Staff Report

To: Salt Lake City Planning Commission
From: Daniel Echeverria, daniel.echeverria@slcgov.com, 801-535-7165
Date: March 18, 2022 (publication)
Re: PLNSUB2021-00740 - Swaner Subdivision – Preliminary Subdivision Plat

Preliminary Subdivision

MASTER PLAN: Northpoint Small Area Plan (2001) – 2022 update in progress
ZONING DISTRICT: Business Park (BP)
PROPERTY ADDRESS: 2691 N 2200 West (approximate)
PROPERTY SIZE: ~430 Acres

SHEET **1**

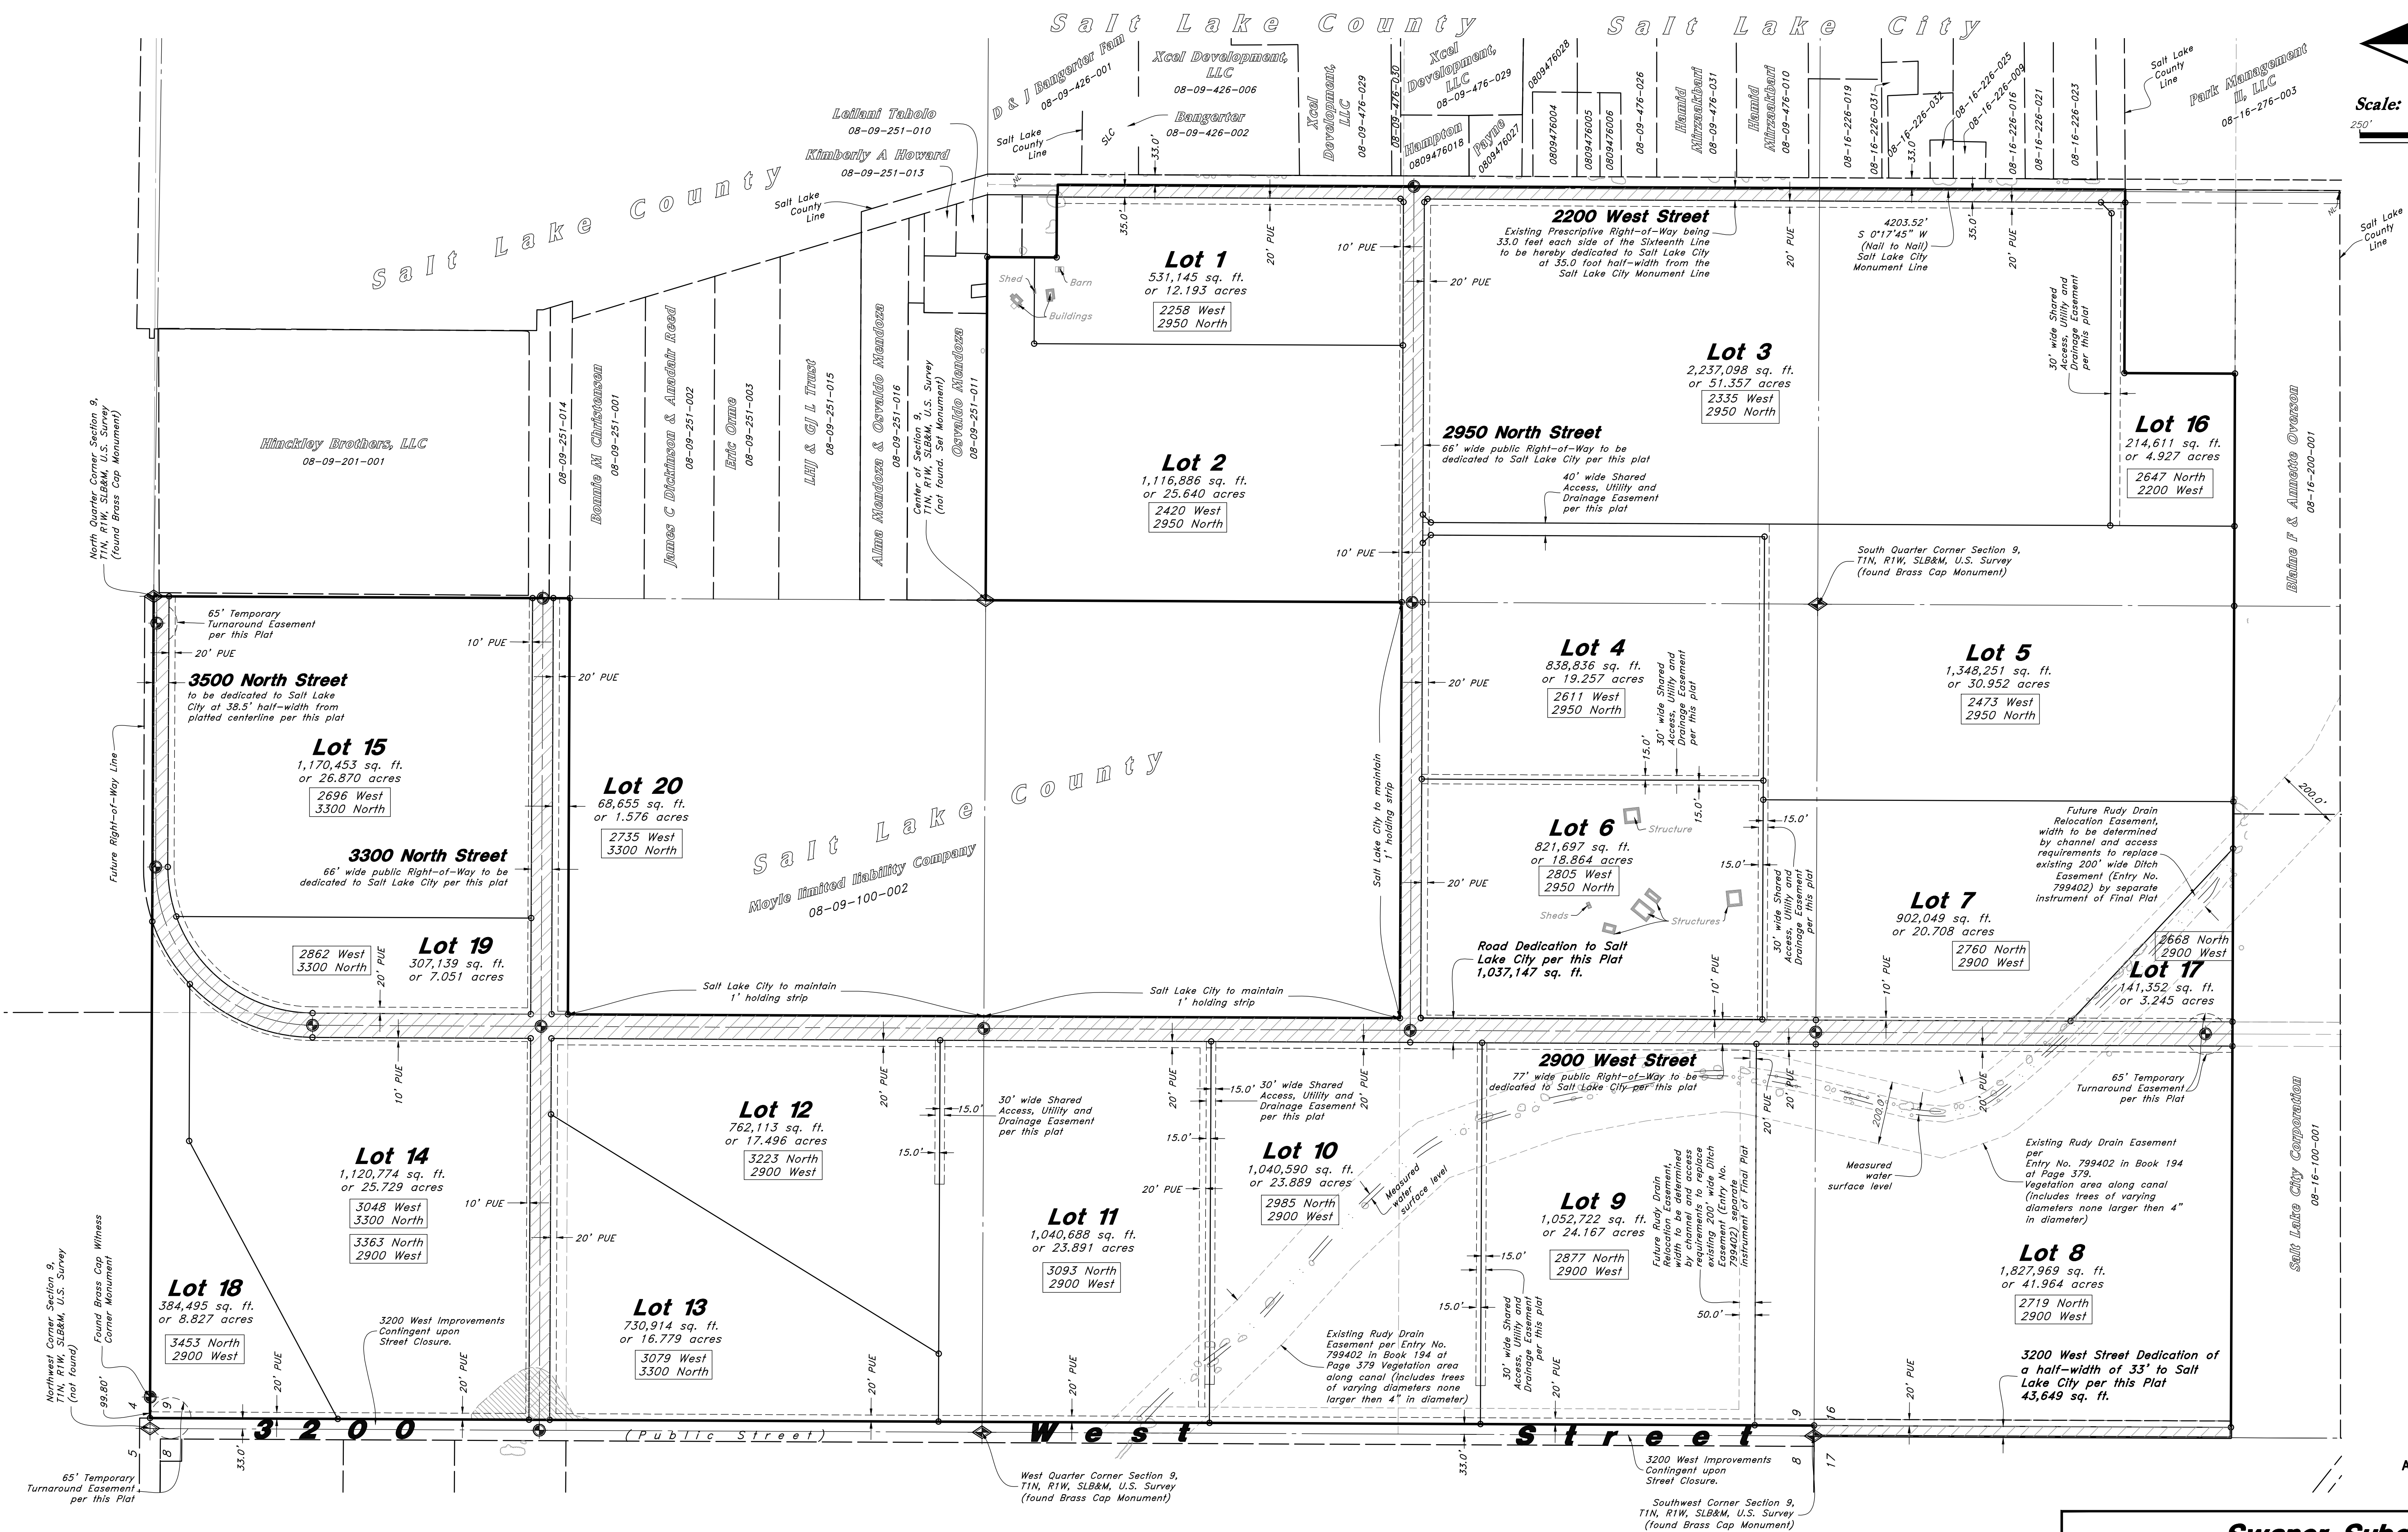
- a. Sheet 1 of the preliminary plat proposes to dedicate 33' for 2200 West along the east boundary of the plat but Sheets 4 and 5 propose to dedicate 38.50' for public use. Please make all sheets consistent. South of this plat, a portion of 2200 West has not been annexed into Salt Lake City and is under Salt Lake County jurisdiction.
